APPEAL: APP/X0360/W/25/3364304

Land between Lodge Road and Tape Lane, Hurst, RG10 0EG

ADDITIONAL WRITTEN REPRESENTATION

Flood Risk Assessment & Drainage Strategy (rev. 6, 14 August 2025)

Summerleaze leachate at the Hurst landfill remediation site.

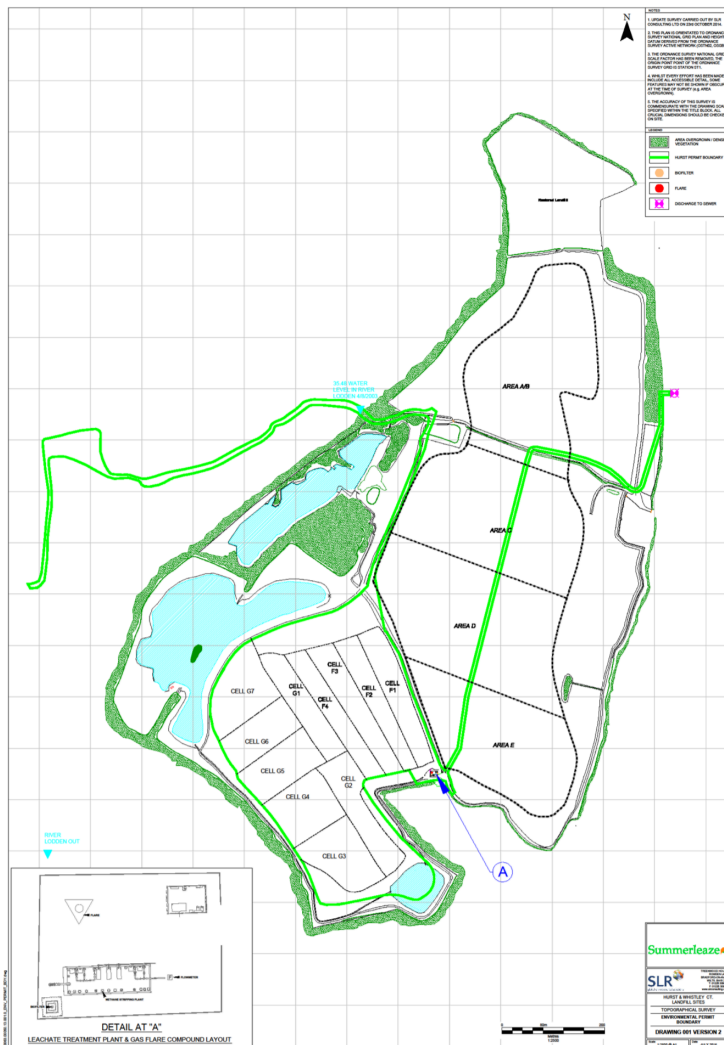
“An unnamed watercourse is located to the west of Lodge Road and **appears** to flow north.

Wrong. This watercourse **does not** flow north.

This watercourse is a specially engineered leachate segregation ditch. It drains leachate runoff, from the remediated Summerleaze Hurst landfill site, which lies immediately to the west of Lodge Road. The ditch drains in a **southerly** direction, to an onsite treatment works at Lea Farm, south west of Hurst. The treated leachate is then pumped to the Thames Water sewer in Lodge Road just to the north of the appellant's site.

The map on the left shows the outline of the capped Hurst landfill site immediately to the west of Lodge Road. The segregation ditch is shown, **flowing south** to a pond near to the onsite treatment works (A). The route of the underground pipe taking treated leachate northwards to the Thames Water sewer in Lodge Road can also be seen (shown marked with a purple symbol).

This watercourse is **not** part of the Hatchgate Ditches. It is a privately owned watercourse, which SLR should be fully aware of as they have in the past advised the owners, Summerleaze.

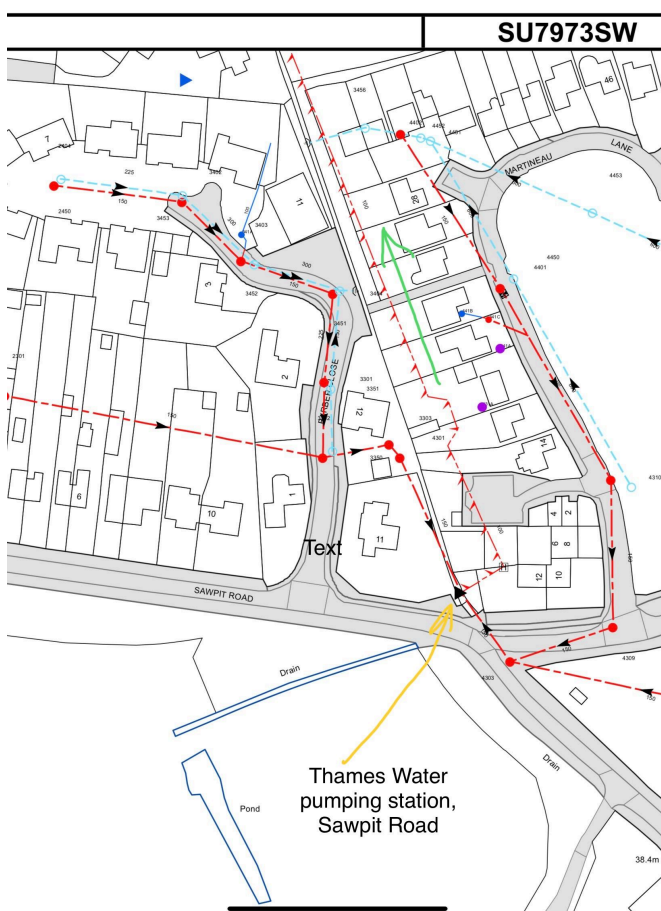
“There is a **proposed** Thames Water foul rising main travelling in a northerly direction adjacent to the western boundary”.

Wrong. This foul rising main is **not proposed**, it **exists**.

It is clearly shown as an existing foul main on the Thames Water sewer map in Appendix C. The appellant has carelessly misinterpreted the TW sewer map, and consequently has **ignored** its existence. A fundamental flaw which immediately renders the FRA&DS **not fit for purpose**.

Note the location of the Thames Water pumping station in Sawpit Road, and the **existing** rising main heading north as indicated by the green arrow.

Black Swan Lake, a reservoir located in Dinton Pastures Country Park, 1.25km to the south west of the appellant's site.

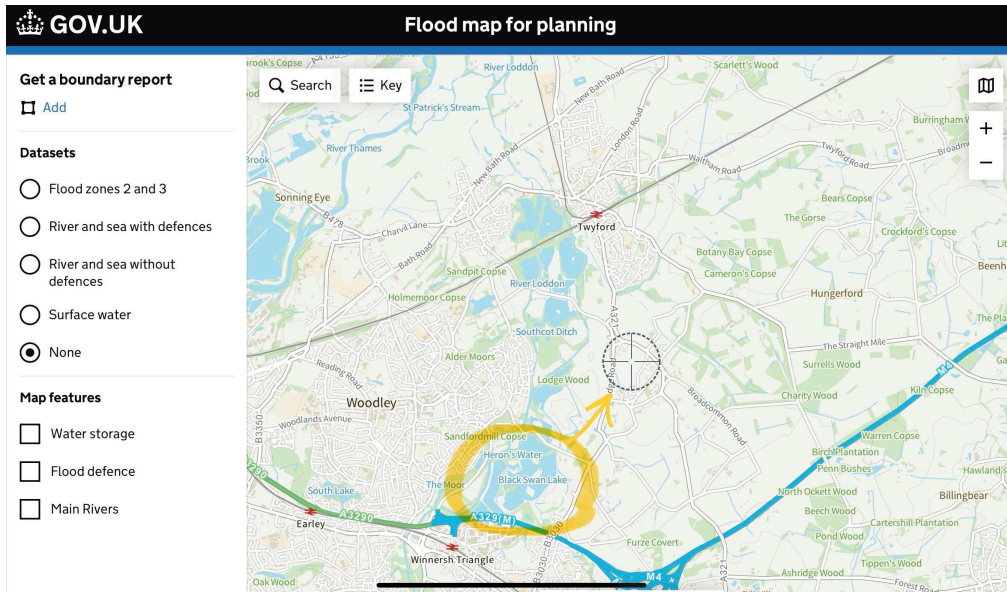
If they had bothered to conduct proper research they would have identified the existence of a significant reservoir known as "Black Swan Lake" immediately downstream of the appellant's site.

The lake has an area of 84 acres, holding a considerable volume of water at an AED above that of the appellant's site.

Figure 2-3 Location Plan Showing Statutory Main Rivers, Subject Catchment Area, Model Inflow Location and Site Boundary

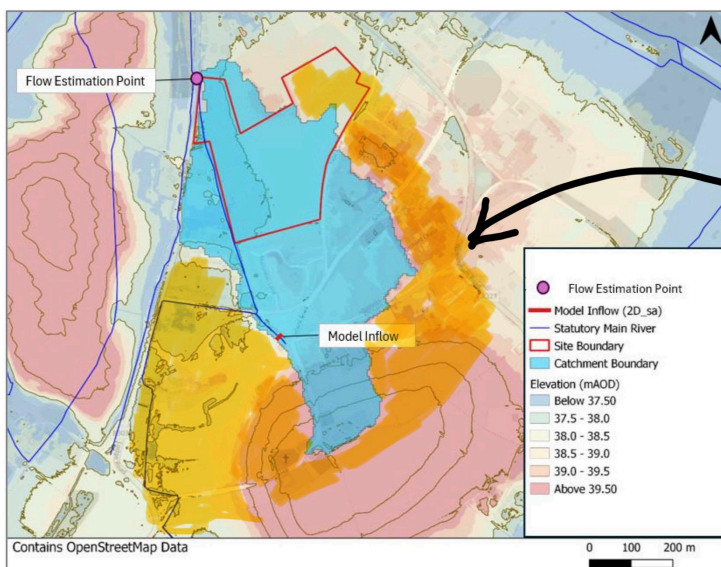
Note the somewhat “truncated” catchment area shown in blue.

The true catchment area, extends into the areas highlighted in yellow, from which local ditches feed into Hatchgate Ditch.

The appellant has used a somewhat truncated catchment area. The appellant wrongly indicates that the source of Hatchgate Ditch (model inflow) is immediately to the south of Sawpit Road, at

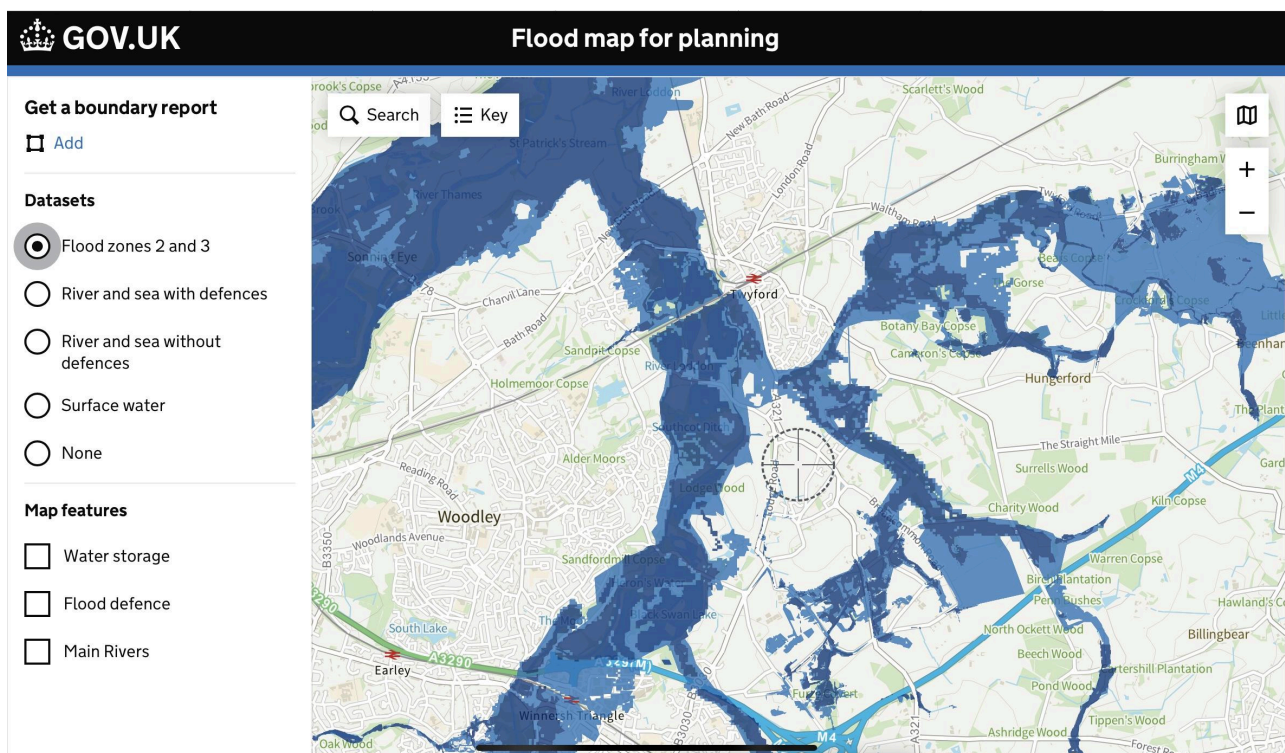
On page 12, section 5.7.2 the appellant admits that for a 1% AEP flood event “**The maximum depth of flooding within parts of the site to be developed for this event is 0.2m (8 inches).**”

“**There is a notable increase in flood extent along the western boundary of the southern development parcel that impinges on the development shown on the illustrative masterplan.**”

The Government Flood Map For Planning clearly shows how Hurst is encircled by a growing extent of flood zones 2 and 3. The “entrapment triangle” is clearly visible.
